Product Type: ZT200 Ref. No. 013

## New Wiring Harness

**Models Affected:**  
**All ZT200's**

Dwg.1

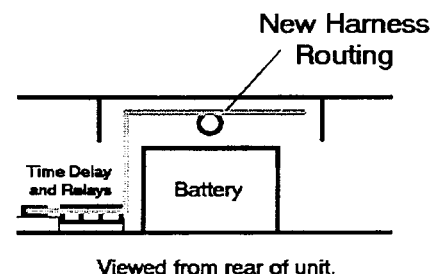
The new harness requires that you re-route it across the top of the frame above the battery and then drop it down along the left-side of the battery (Dwg.1). You will have to install the new relay mount 90 degrees clockwise from the previous location and an additional hole must be drilled in the engine deck (Dwg.2). The new relay mount will also allow for the time delay to be mounted on it.
